Work Order ID 60863

Item Name: Head Rest

DRAWING NO. D3303	TITLE HEAD REST	REV. B	DART AEROSPACE LTD ENGINEERING ORDER		D.E.O. NO. D3303-B-1	SHEET NO. SHEET 1 OF 1	SCALE NTS
DRAWN AJS	CHECKED <i>h</i>	MFG. APPR. <i>h</i>	APPROVED <i>h</i>		DE APPR. <i>h</i>		
DATE 08.10.15	DATE <i>08.10.15</i>	DATE <i>08/10/16</i>	DATE <i>08/10/16</i>		DATE <i>08/10/16</i>

D3303-041 HEAD REST

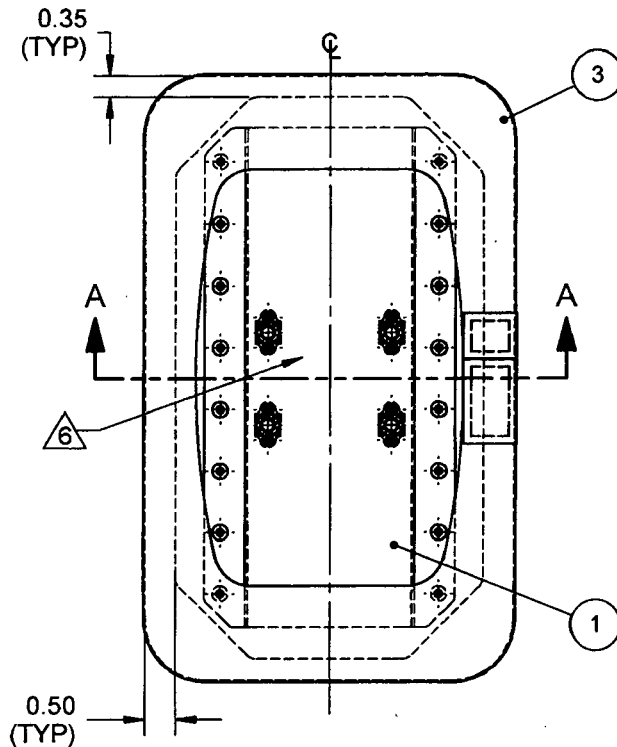
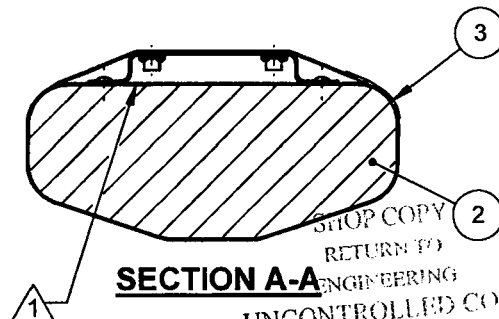
SHEET 1 ADD 1300L ADHESIVE BY 3M TO NOTE 1 AS FOLLOWS:

- 1) BOND D3305-1 FOAM TO D3303-043 BRACKET ASSEMBLY USING 3M 1300 OR 1300L ADHESIVE (0.002" TO 0.010" THICK) IN ACCORDANCE WITH MANUFACTURER'S INSTRUCTIONS
